talbot mill

DESIGN & ACCESS STATEMENT (DAS) ADDENDUM

project:
talbot mill • manchester

document title:
DAS addendum

original application (2017) vs. S73 application (2018)

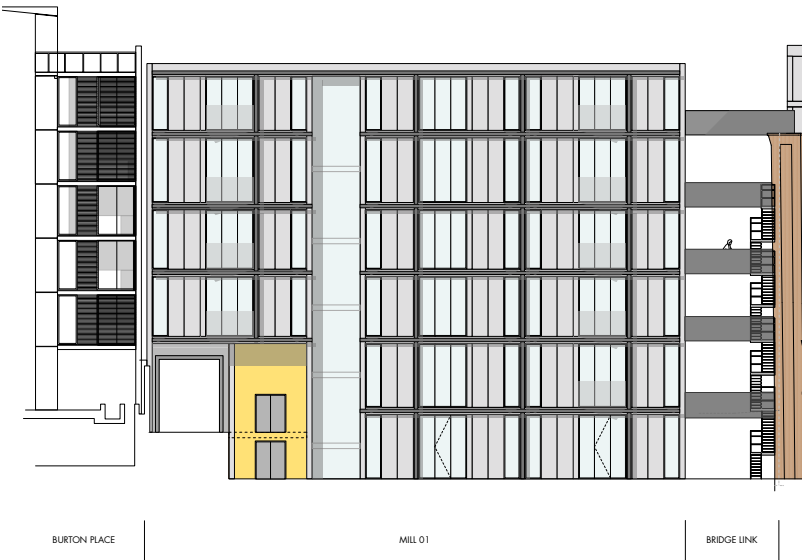
Following approval of the original application (2017), during detail design development there were a number of minor design changes. These were captured as part of the aforementioned s73 application. The main items including the following (as listed on the approval letters):

- fenestration changes to new build and extension to mill 01
- additional windows to outrigger [mill 02]
- increase in height of mill parapets and roof top extensions
- increase in height of new build
- relocation and extension of time keeper's lodge
- landscape changes

The landscape changes were driven by the construction sequencing of the mill 01 rear extension. In order to gain access to the rear elevation, the time keeper's lodge needed to be relocated. This resulted in the re-design of the ramp access and setting out of ancillary areas.

The increase in height of each of the building was attributed to a more detailed analysis of minimum floor and roof build-ups, along with maintaining minimum clear headroom in new build elements (e.g. roof top extensions).

The development of fenestration setting out and operation were also revisited to ensure they met the requirements of internal spaces in terms of minimum purge ventilation as well as ease of operation (i.e. height of ironmongery/opening type etc...).

02.05 site section - courtyard

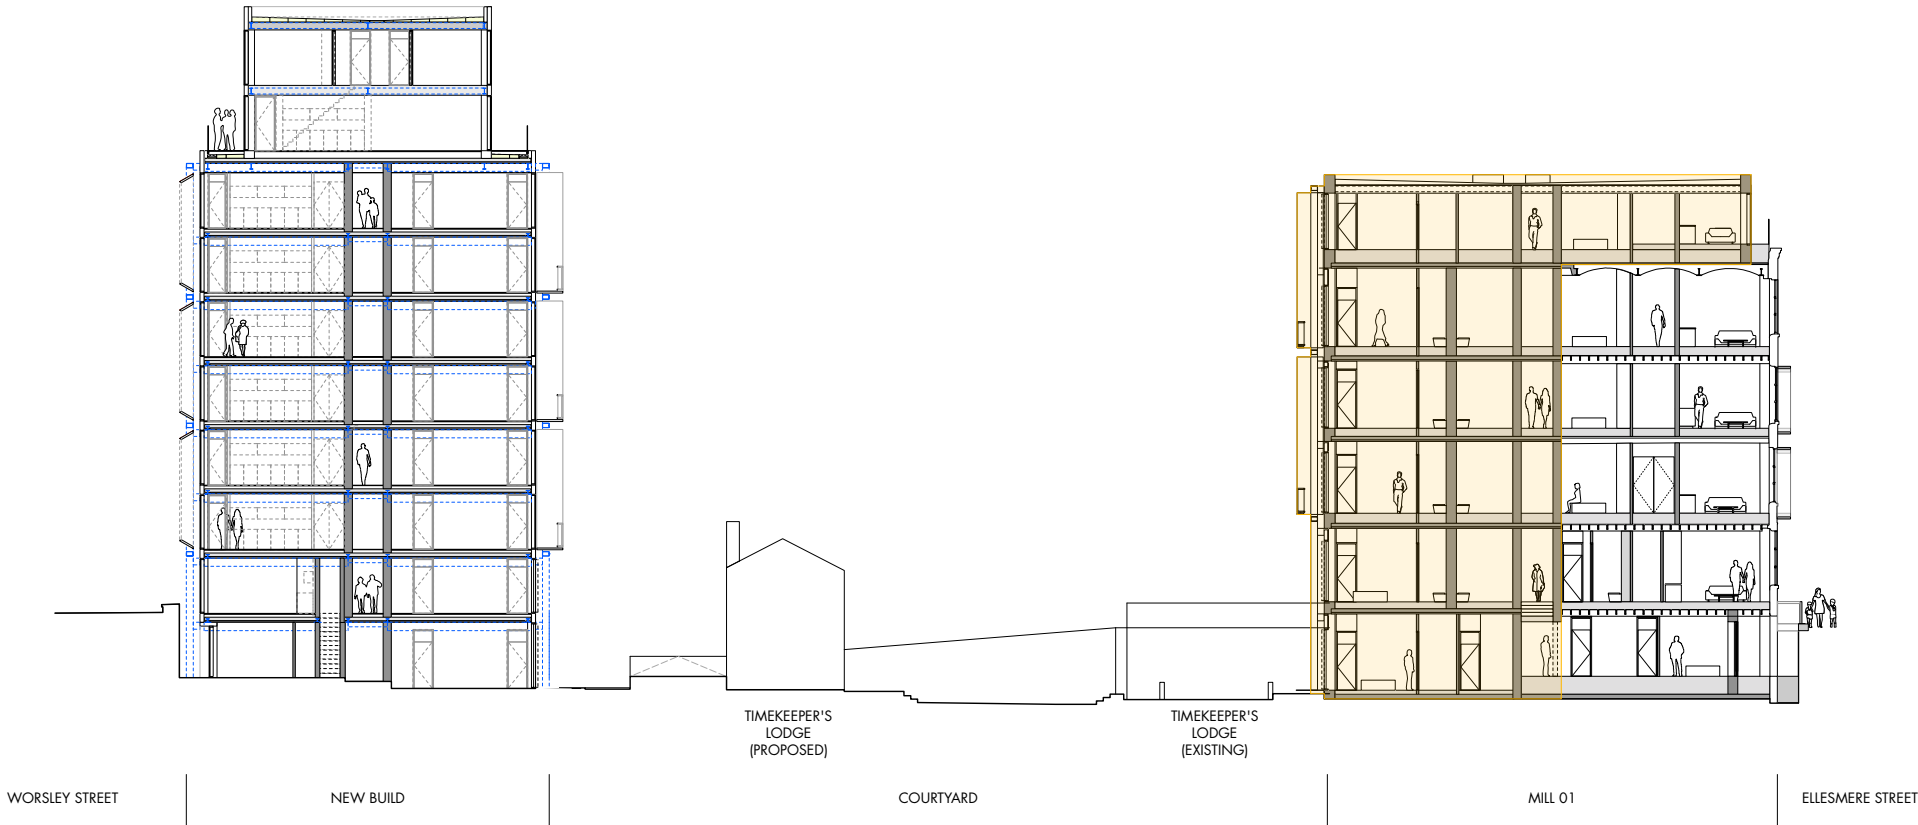
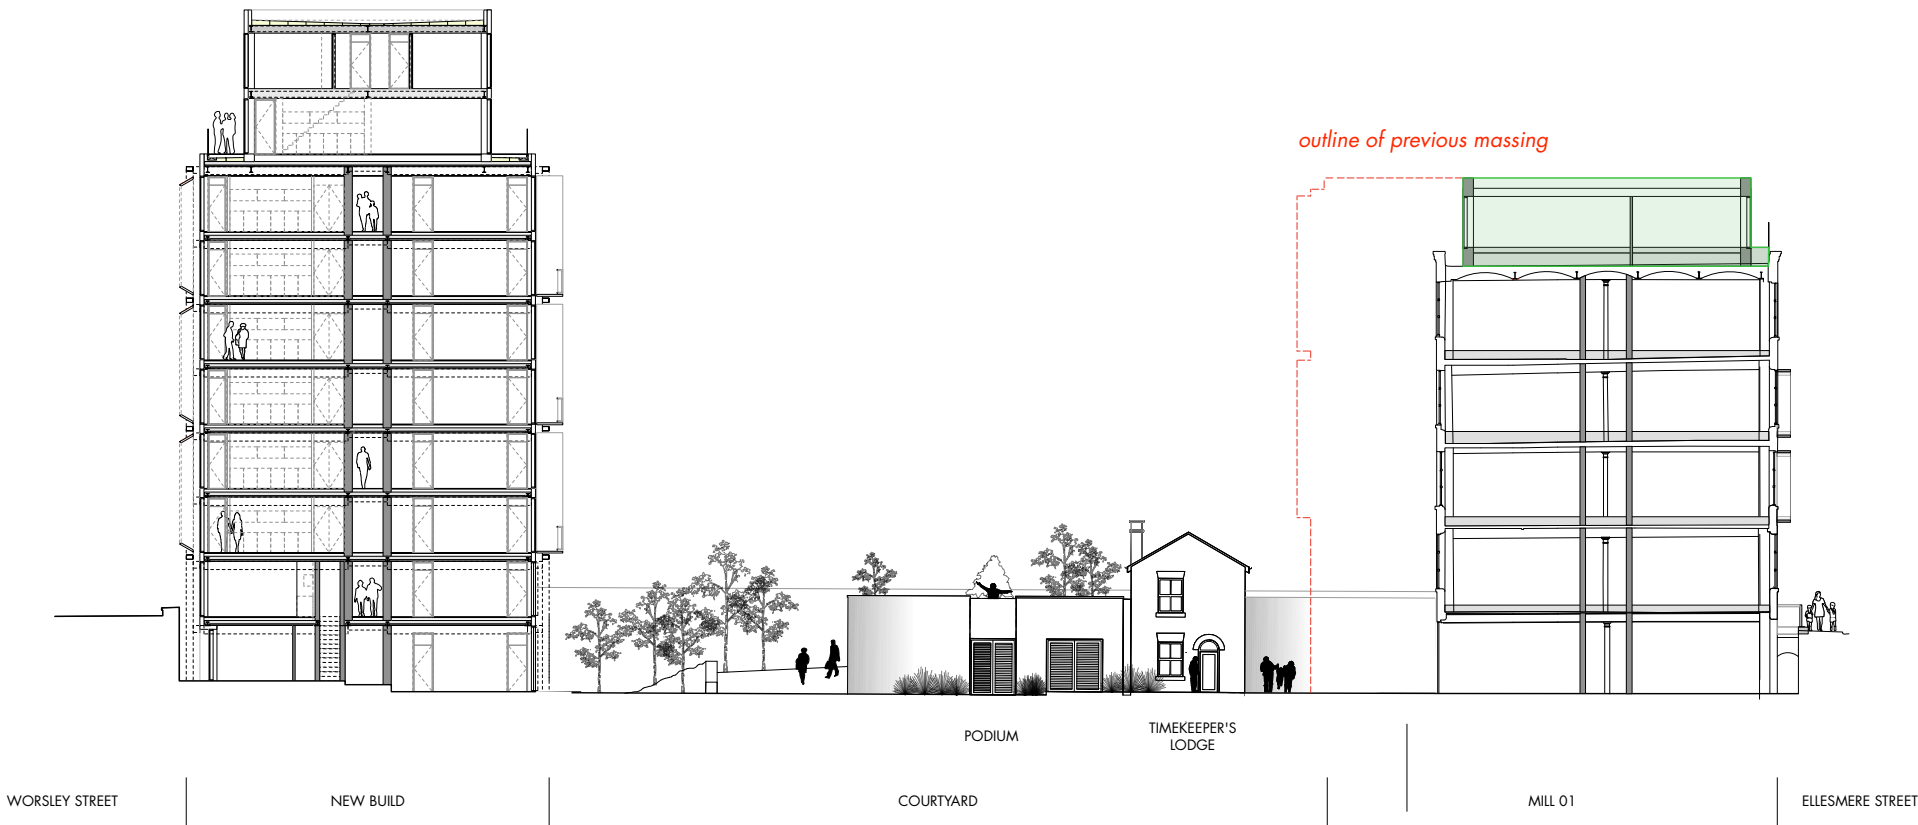
mill 01

- single storey roof extension
- rear of existing building demolished
- new rear extension

- time keeper's lodge relocated

mill 01

- single storey roof extension
- rear of existing building retained

- retain time keeper's lodge in vicinity of original location
- new podium feature

02.09 elevation - courtyard - mill 01

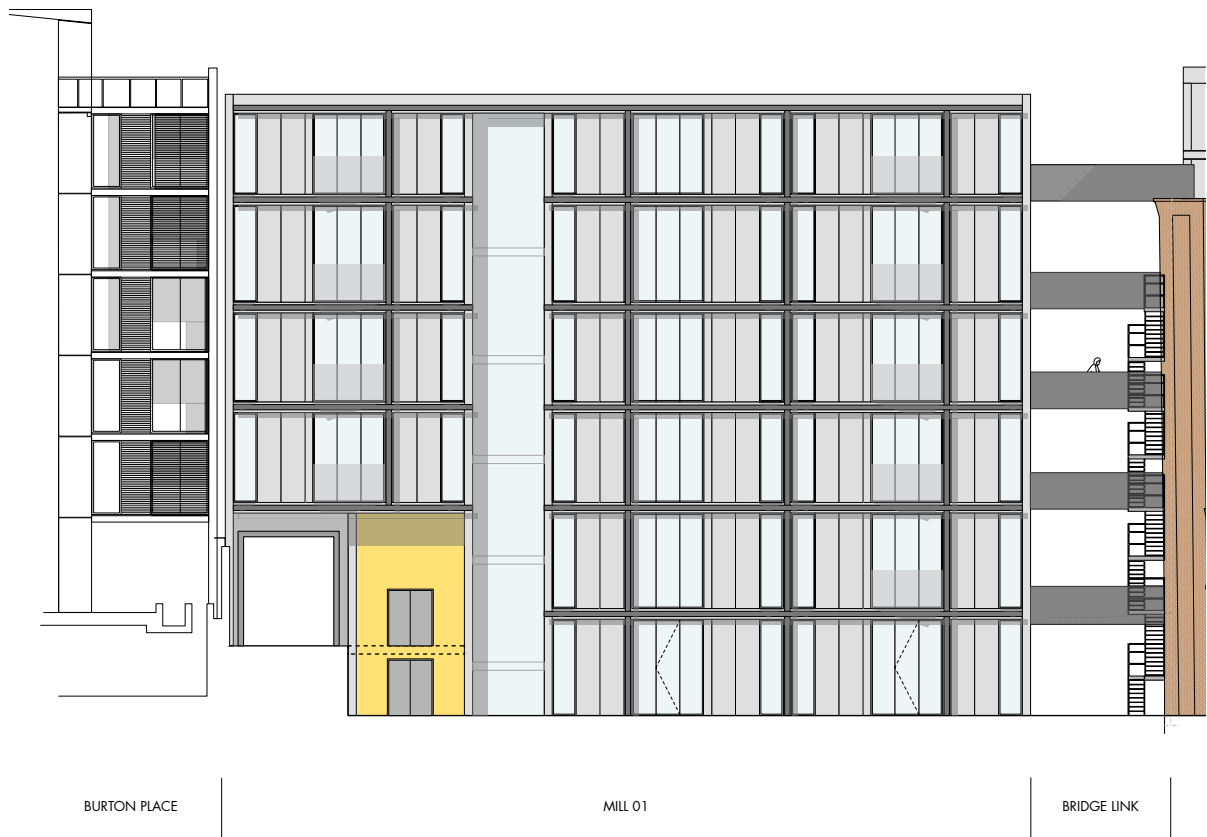
original proposal

- rear of existing building demolished
- new rear extension
- sub-station within footprint of mill 01

design amendments

- existing facade retained
- outrigger demolished
- fixed glazing to existing openings
- existing fire escape stairs retained
- existing ginnel entrance enlarged

03.02 landscape podium - plans

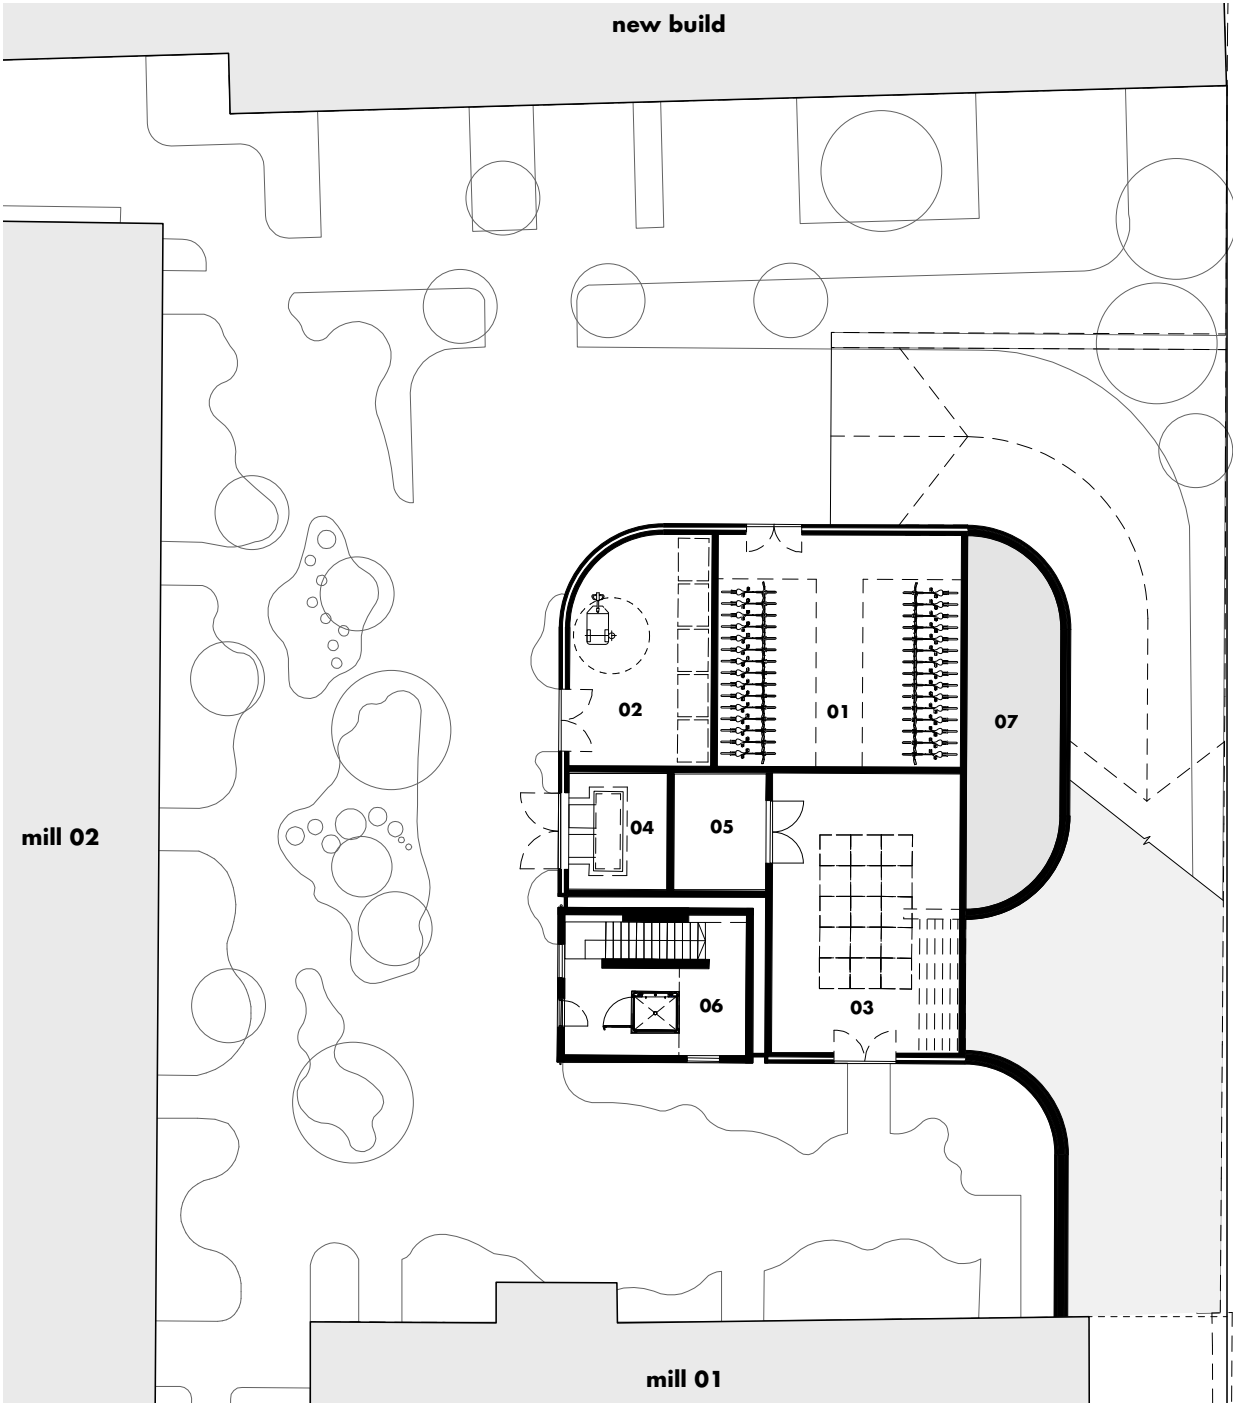
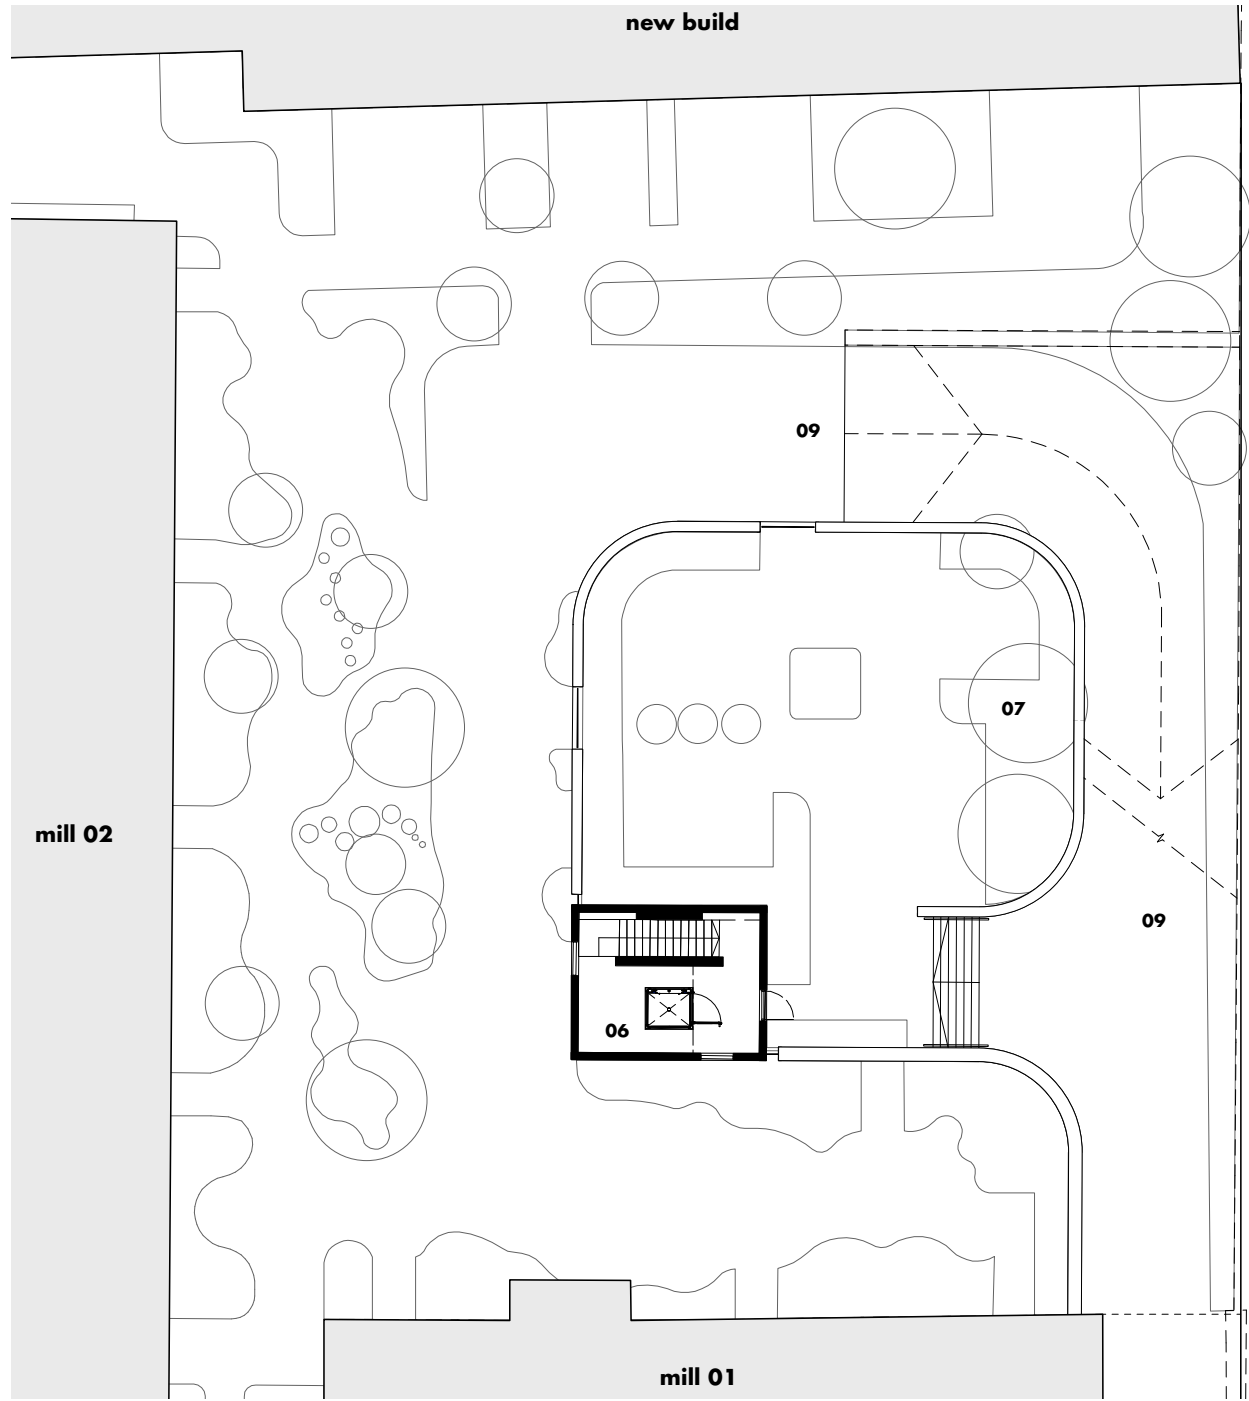
With the omission of mill 01 rear extension, the proposed podium structure would accommodate all ancillary areas. The relationship and massing of this new structure has been designed to reflect the original condition. Within this layout, it is proposed to position the time keeper's lodge within the vicinity of the original location.
